# Technical Service Bulletin

GROUP <b>BODY ELECTRICAL</b>	NUMBER <b>24-BE-004H</b>
DATE <b>FEBRUARY 2024</b>	MODEL(S) <b>VENUE (QX)</b>

**SUBJECT:** DISPLAY AUDIO BLACK SCREEN SOFTWARE UPDATE

**Description:** Some Venue (QX) vehicles equipped with Display Audio 2.0 and a key start ignition may exhibit an intermittent black screen during operation. Follow the procedures in this TSB to download and install the software update for the head unit.

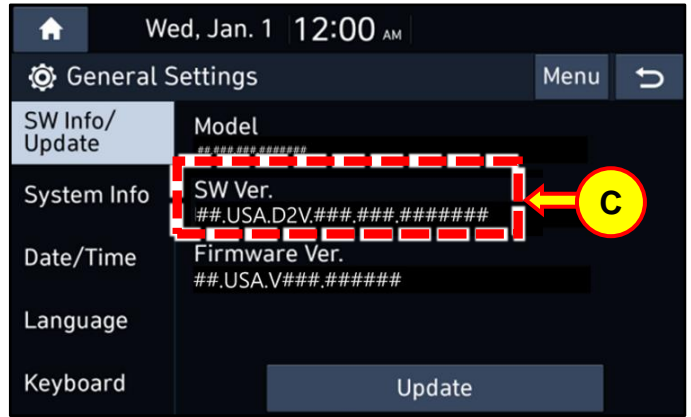
4. Confirm the SW Version (C) matches the “old” version listed below.

- Old Version (before update):  
QX.USA.D2V.003.200.220927
- New Version (after update):  
QX.USA.D2V.003.200.230302

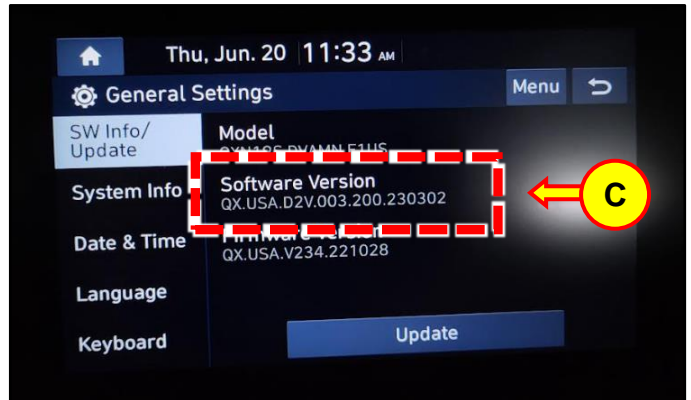
8. After the update has completed, confirm the SW version (C) has been correctly updated by referring to the 'System Info screen'.

- New Version (after update): QX.USA.D2V.003.200.230302
